STATE OF HAWAII
DEPARTMENT OF TRANSPORTATION
HIGHWAYS DIVISION
HONOLULU, HAWAII
"AS-BUILT"
PLANS FOR
OLD KEA'AU-PAHOA ROAD RESURFACING
KEA'AU TO KEAAU HIGH SCHOOL
PROJECT NO. 139A-01-05M
DISTRICT OF PUNA
ISLAND OF HAWAII

CHANGES MADE DURING CONSTRUCTION HAVE BEEN INCORPORATED ON THESE PLANS EXCEPT CHANGES IN THE ORIGINAL THEORETICAL QUANTITIES. FOR ACTUAL QUANTITIES, REFER TO PROJECT LEDGER AND/OR COMPUTATION BOOK.

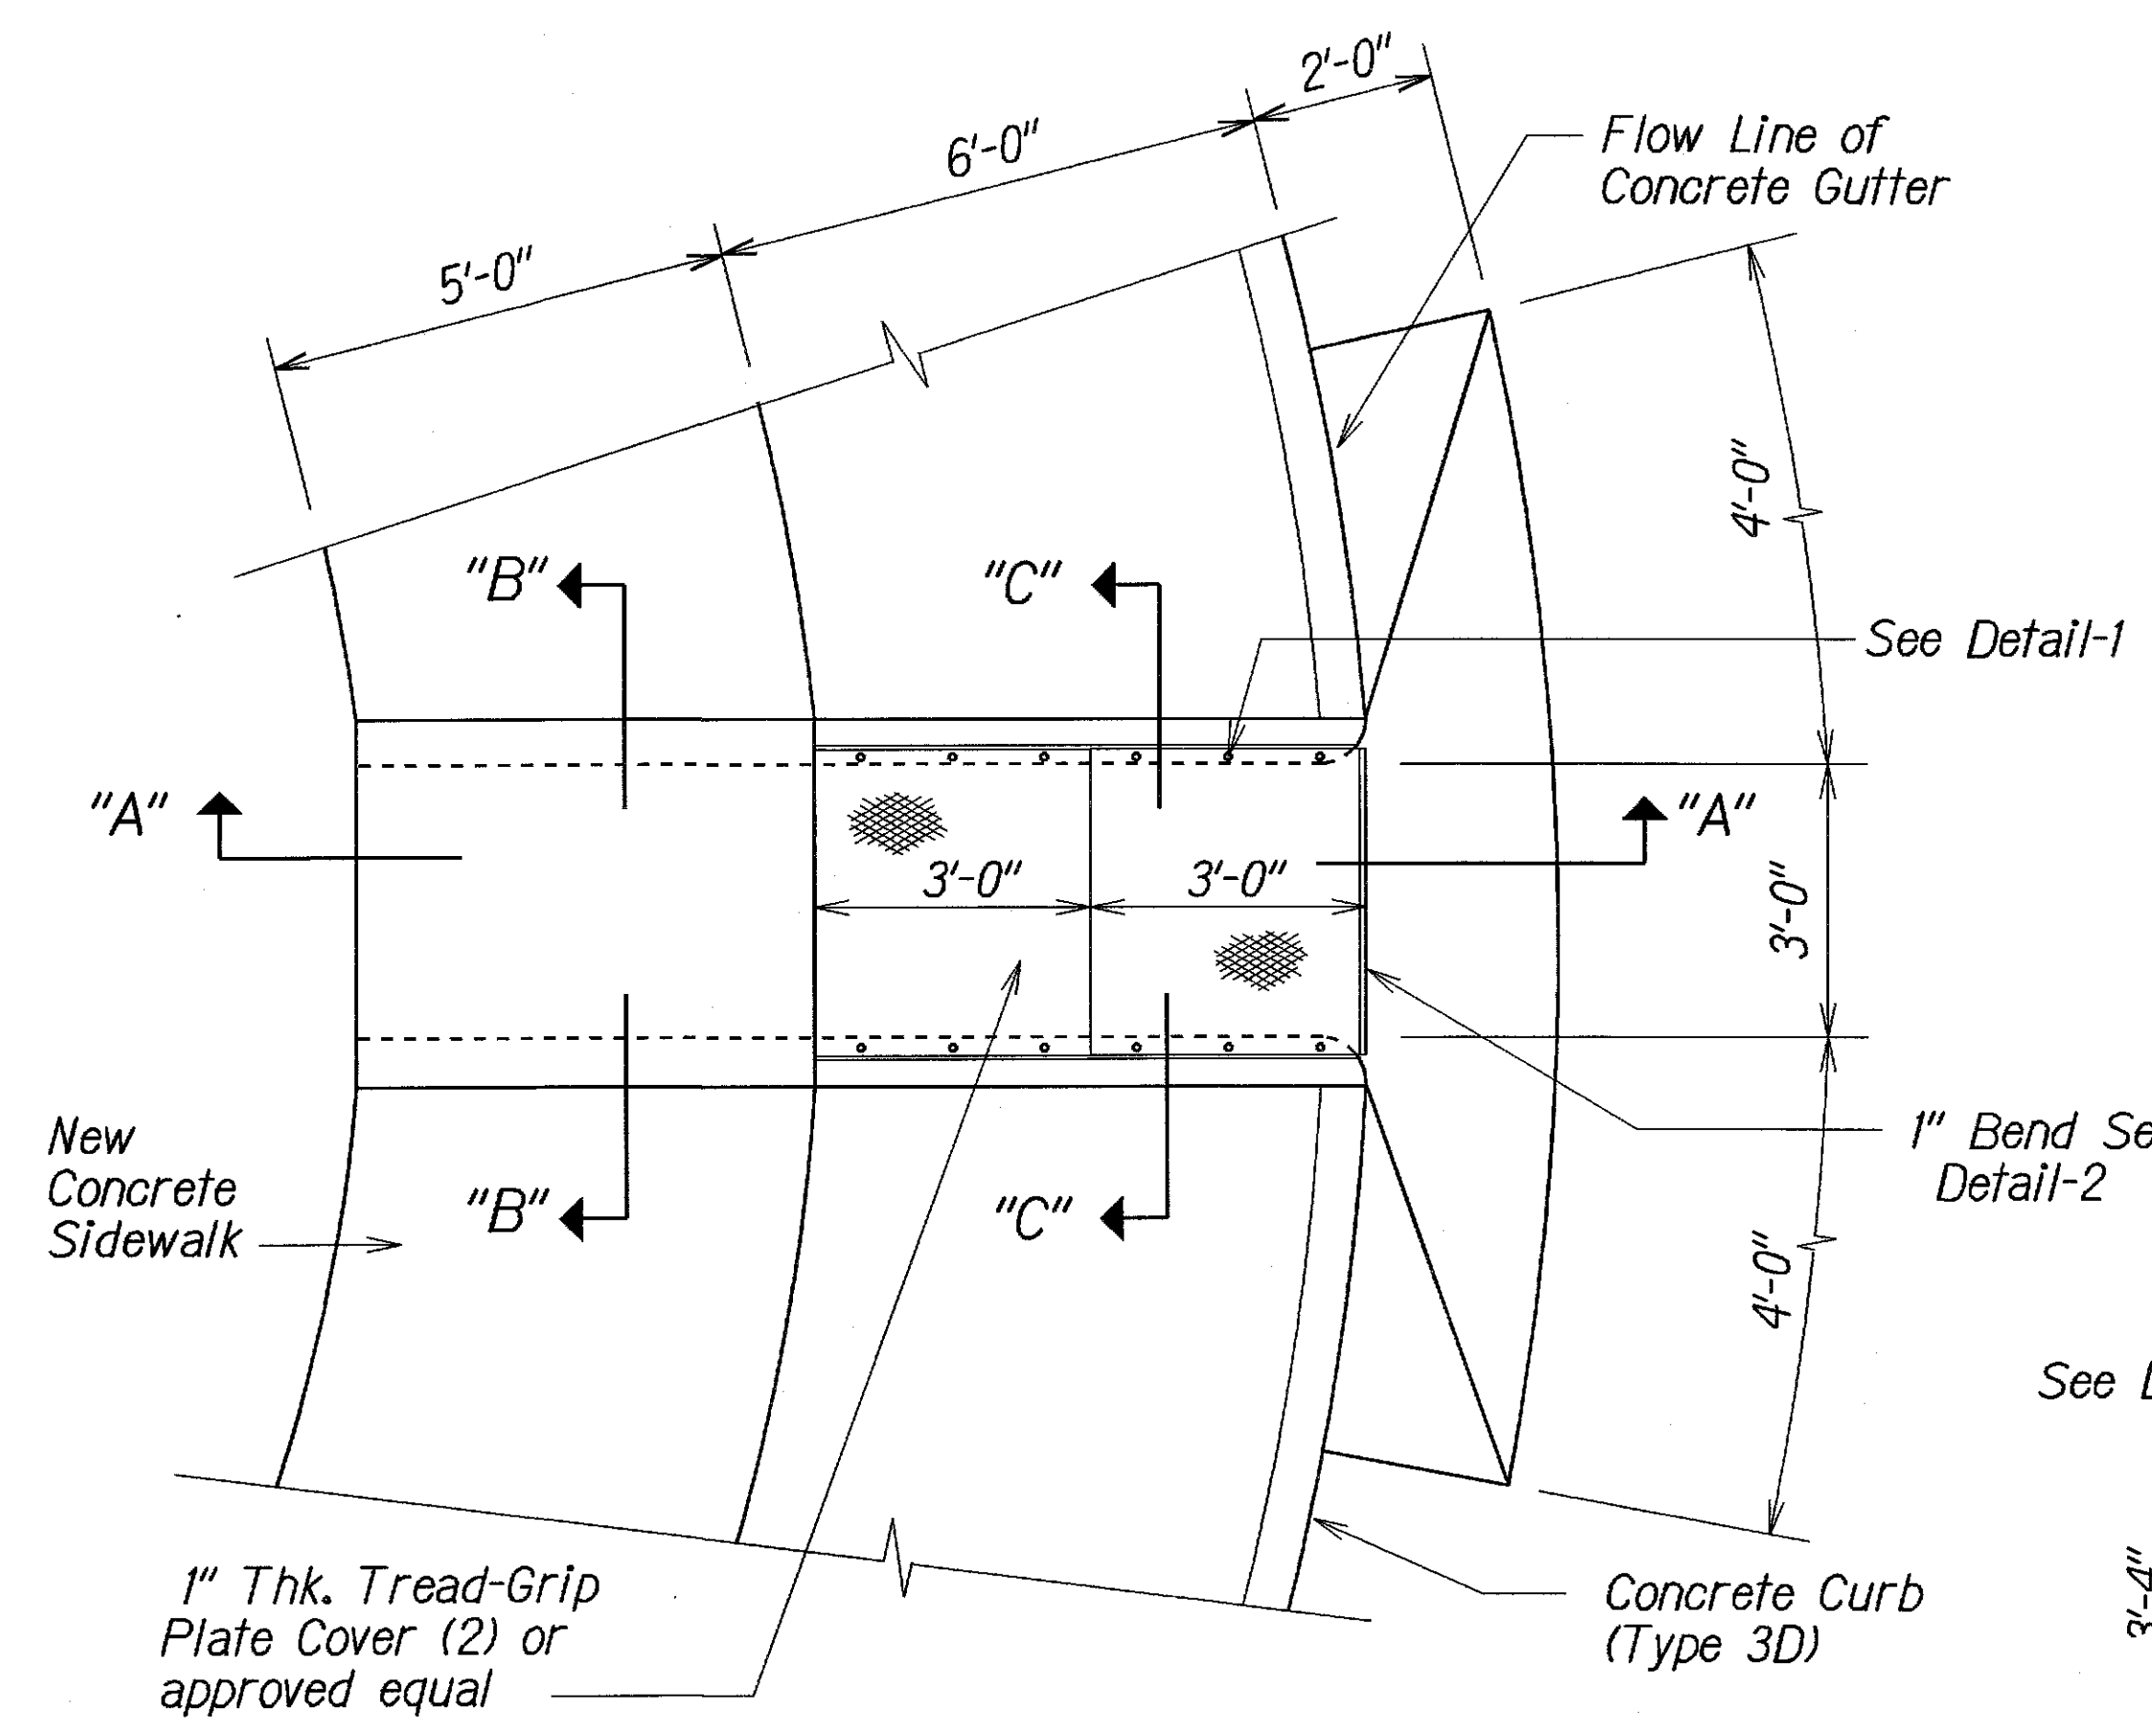
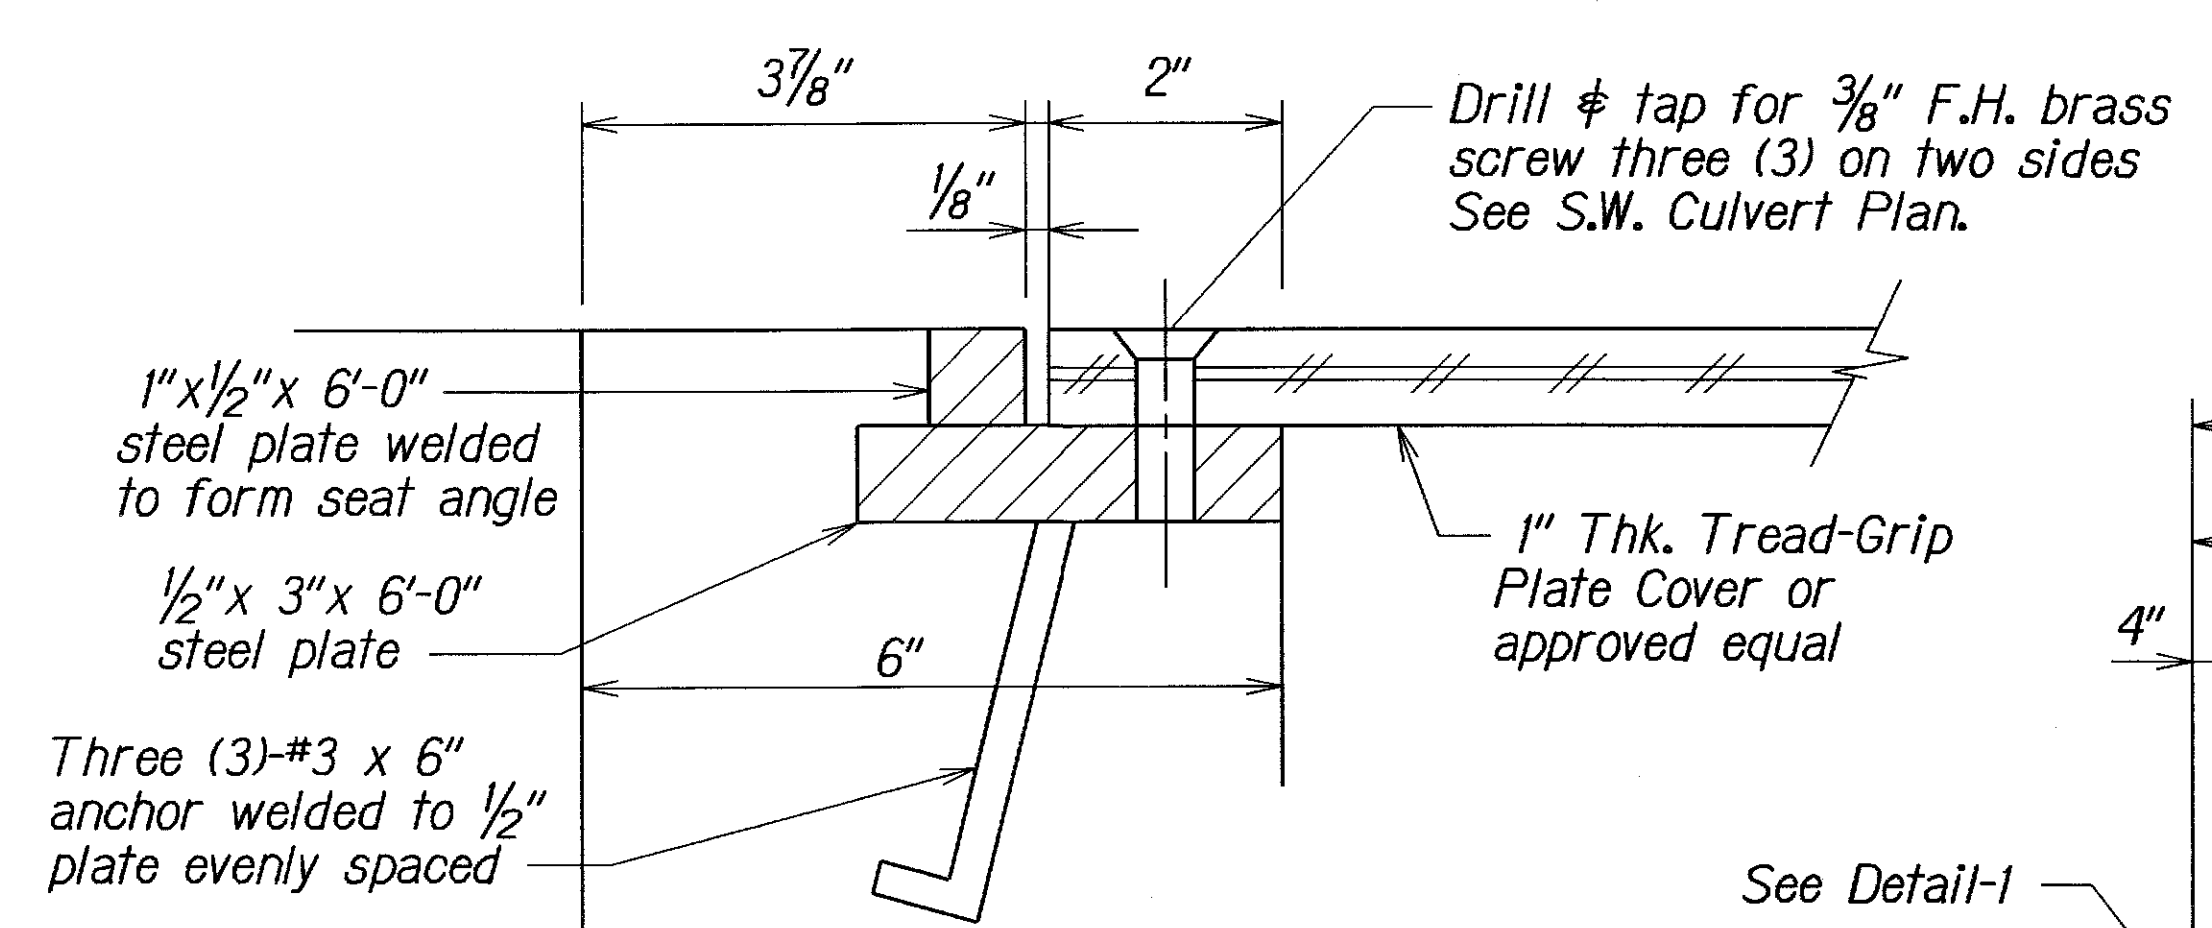
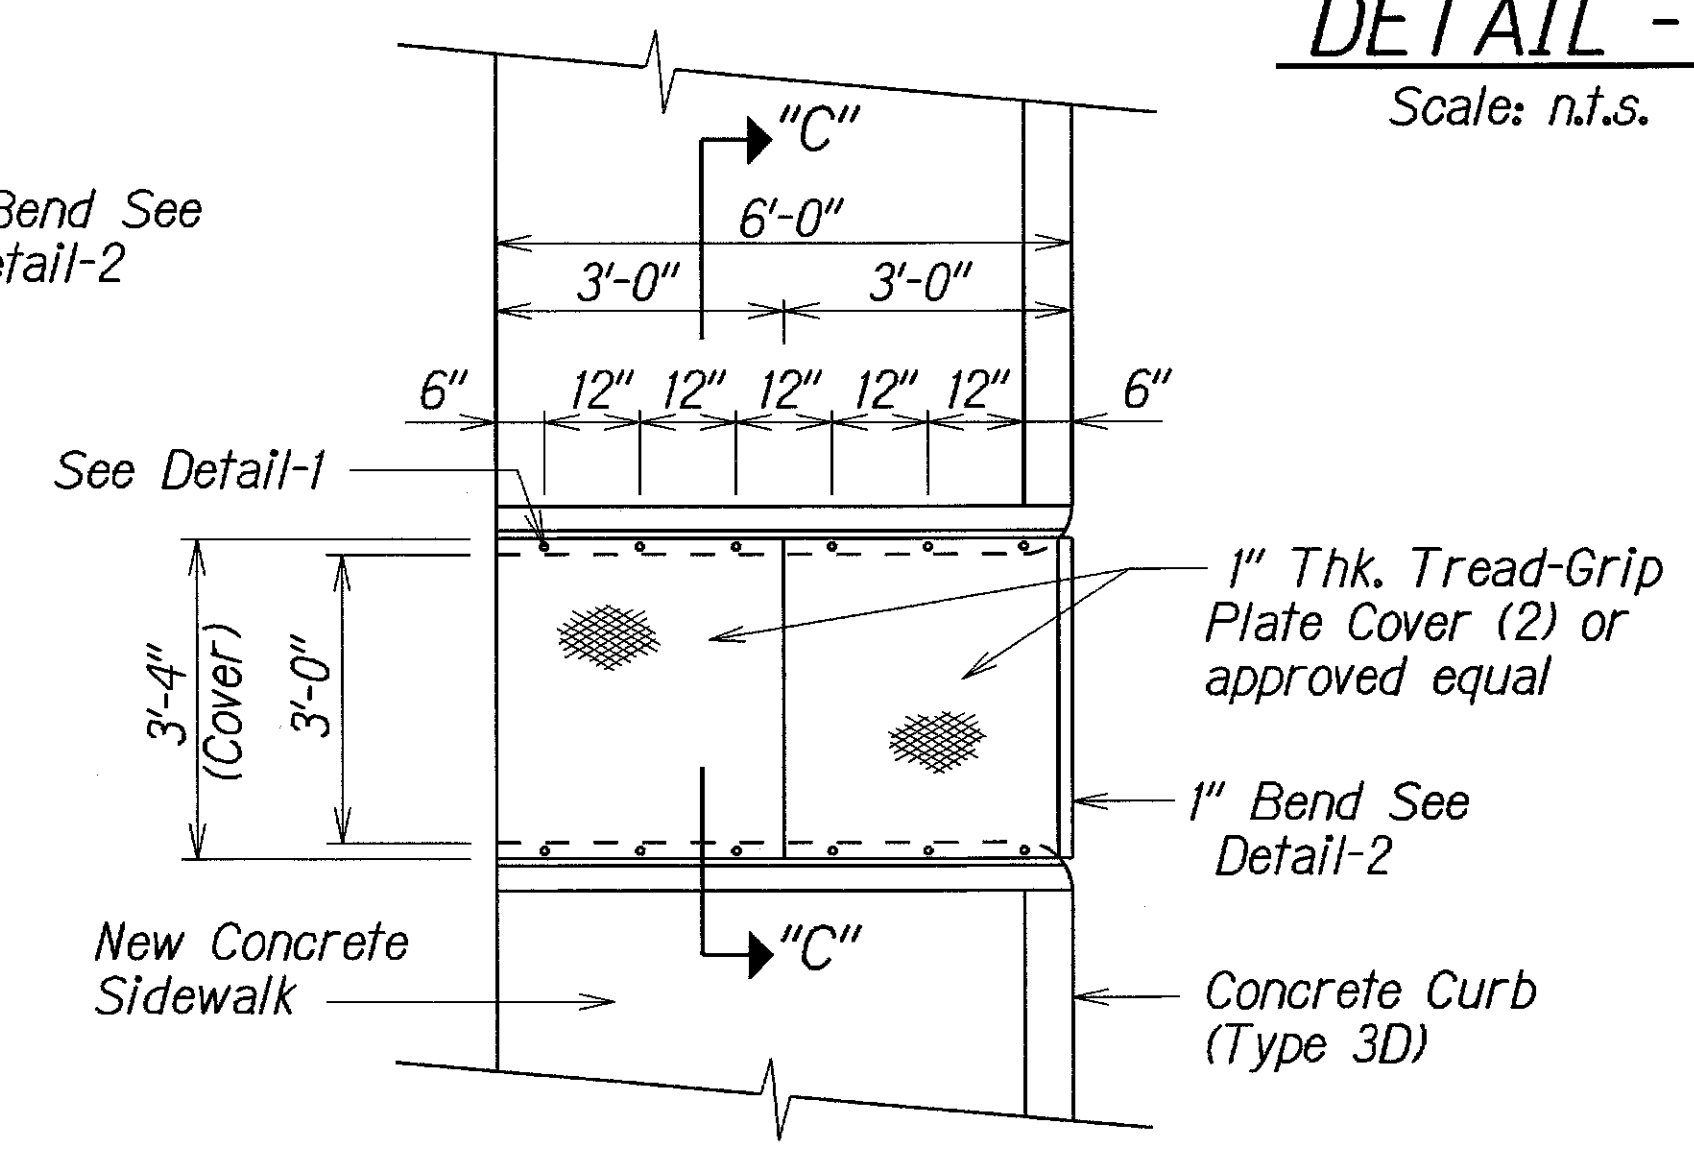
6/07/07	Revise culvert details and notes, per Addendum No. 1.
DATE	REVISION
STATE OF HAWAII DEPARTMENT OF TRANSPORTATION HIGHWAYS DIVISION TYPICAL SIDEWALK CULVERT DETAILS OLD KEA'AU-PAHOA ROAD RESURFACING KEA'AU TO KEAAU HIGH SCHOOL PROJECT NO. 139A-01-05M Scale: As Shown Date: Nov., 2004 SHEET No. 6 OF 7 SHEETS
